Investigation Summary Report Update 3

Date: 12 December 2017

Introduction

This investigation is into the activities of heavy vehicle specialist certifier Peter Wastney and was initiated following a crash on 27 August 2017, where the catastrophic failure of a drawbeam on a truck JWN197 resulted in the detached trailer travelling a significant distance before coming to rest against a bank.

Figure 2 Drawbeam design 17452, Isometric view (left), Isometric view rear (right)

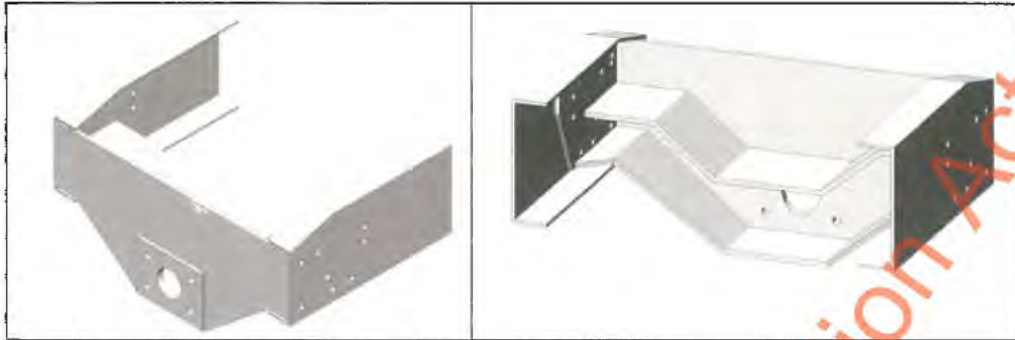
The basic design of the drawbeam is shown in Figure 2.

The drawbeam was certified on [REDACTED] in January 2016 before being replaced due to failure after approximately 40,000km of service on the 8th of December 2016. The total approximate service life of the drawbeam is 79,000km.

Overlaying the SolidWorks CAD files shows that both drawbeam designs, 17542 and 18877, are identical. The only differences are in the truck chassis dimensions and the bolt group detail. The SolidWorks stamp dates and suppressed features in the SolidWorks model tree also support this conclusion, Figure 4 and Figure 5.
